PARTS & SERVICE NEWS

REF NO.	AT04175
DATE	December 7, 2004

SUBJECT: REPAIR PROCEDURE FOR DAMAGED SPHERICAL WASHER FOR DIFFERENTIAL

APPLICATION: WA300-3: 55300-55389
WA300L-3: 54005-54456
WA320-3: 54110-54456
WA320-3: 54220-54456
WA320-3C: 54114-54456

Fig.1

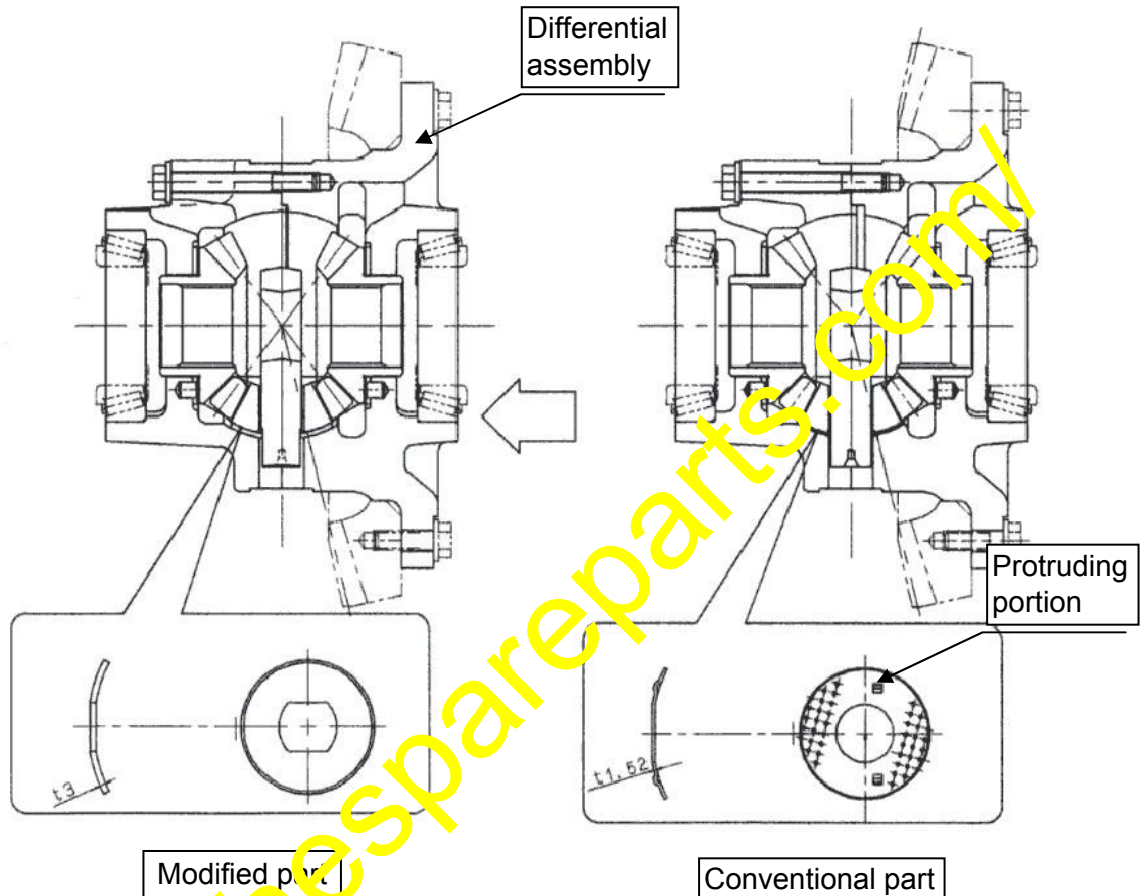
A protrusion is provided on the spherical washer used for differential to lock, however, variations in the accuracy of parts can cause cracks from the portion.

Therefore, durability of the part has been increased by modifying the part to lock between the elongate hole inside the washer and the end surface of the cross shaft. If the washer is damaged, replace it with this differential assembly.
